## Report to the Future Melbourne (Planning) Committee

### Ministerial Planning Referral: TPM-2019-30 346-350 Macaulay Road, Kensington

5 May 2020

1. The purpose of this report is to advise the Future Melbourne Committee of a Ministerial Planning Application PA1700727 for land located at 346-350 Macaulay Road, Kensington (refer Attachment 2 – Locality Plan).

Figure 16 - Ground Floor Plan extract showing swept paths adjacent to the substation entry

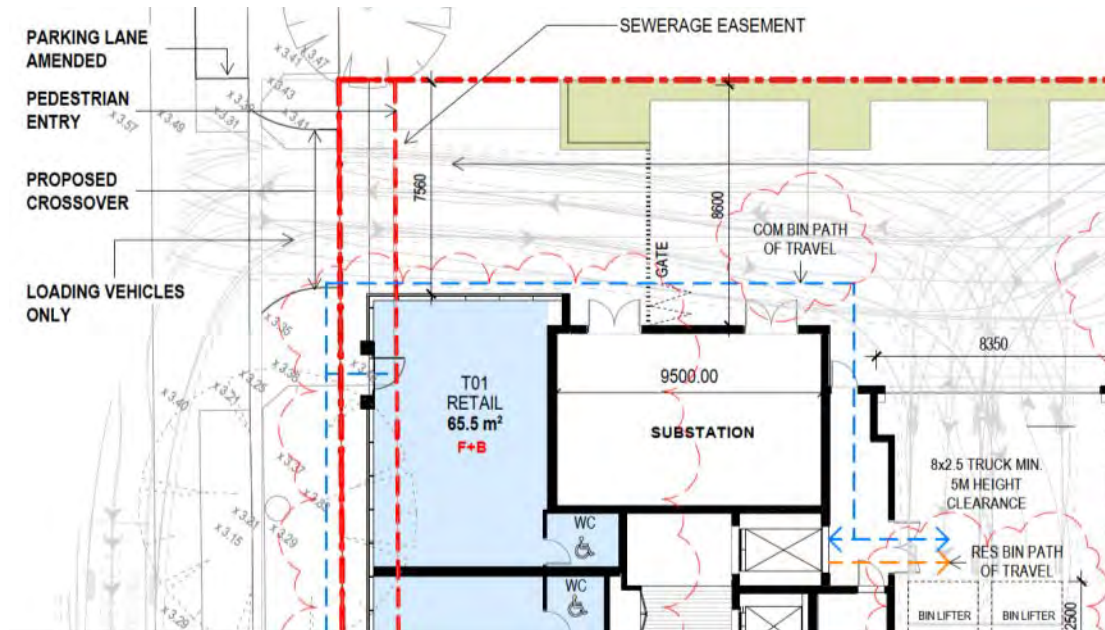
The amended plans do not, however, address the Urban Designer's concerns relating to the location of the doors to the substation. The permit applicant noted that this could not be changed, as the setback of the substation is necessitated by swept paths and access arrangements required for an 8.03 metre long Council hook truck for waste collection. These swept paths are shown on the ground floor plan and are visible in the extract at Figure 16.

Figure 20 - Ground Level Plan extract highlighting windows within 1 metre of the basement ramp. From Drawing TP01.04

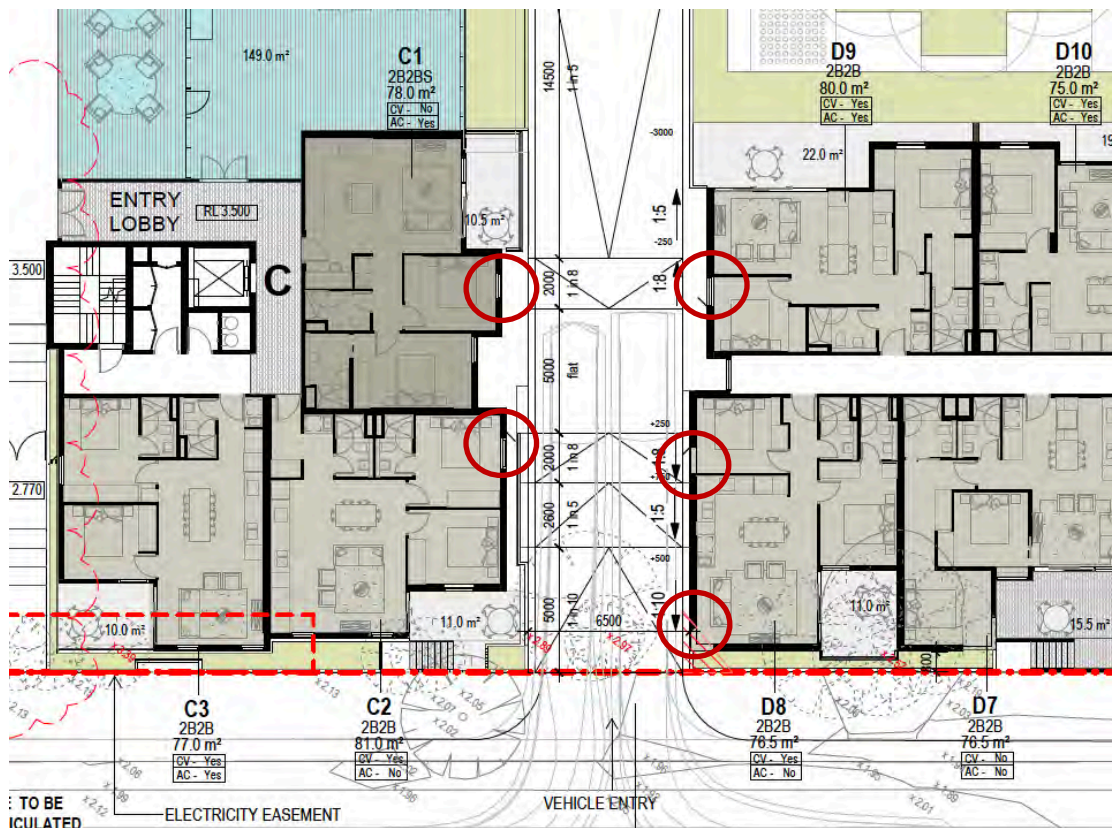
As illustrated in the extract at Figure 14, a total of five habitable room windows are located within one metre of the accessway, and do not meet the (modified) requirement at Standard D12.

Of great concern, however, is the south facing bedroom window of Dwelling D8, which would have no outlook and limited access to daylight. This matter was discussed with the permit applicant and project architect, who advised that the window in question could be relocated to the western wall. This solution is considered to be acceptable for this second bedroom, and will be included as a recommended condition on permit.
